# Intel® Celeron™ Processor Specification Update

Release Date: January 1999

Order Number: 243748-011

The Intel® Celeron™ processor may contain design defects or errors known as errata which may cause the product to deviate from published specifications. Current characterized errata are documented in this Specification Update.

Figure 20. Side View Space Requirements for the Boxed Processor

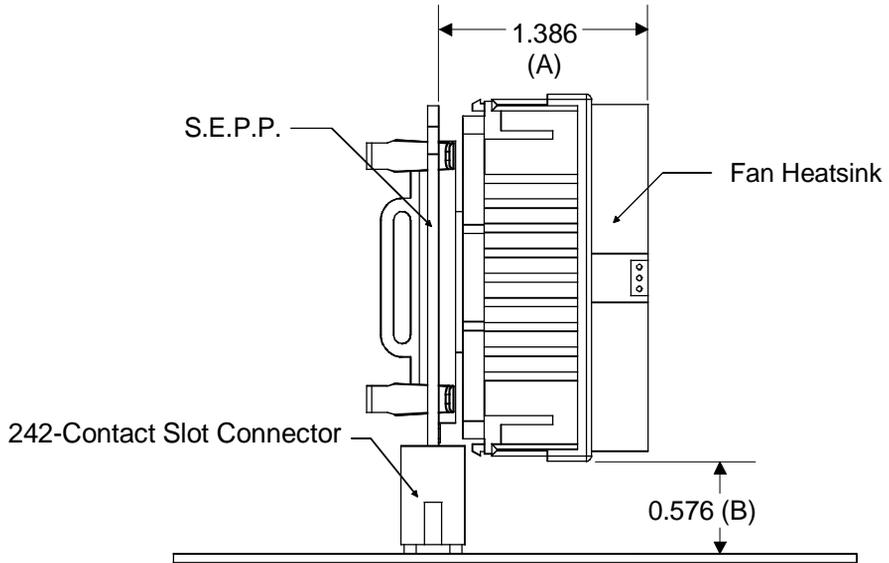
Figures 20, 21, and 22, and Table 34 of Section 6.2 of the *Intel® Celeron™ Processor* datasheet show incorrect fan heat sink dimensions for the boxed Intel Celeron processor. The correct figures and table are shown below.

The maximum depth of the fan heat sink to the processor substrate should be 1.386", not 1.291" max. The minimum height clearance above the baseboard should be 0.576", not 0.485". The fan shroud height should be 2.02" and 4.74", respectively, not 2.19" max. and 4.90" max. Figure 22 should show reference "G" for the minimum airflow keepout zone from the inlet of the fan heat sink, and reference "F" for the minimum airflow keepout zone from the ends of the fan heat sink.
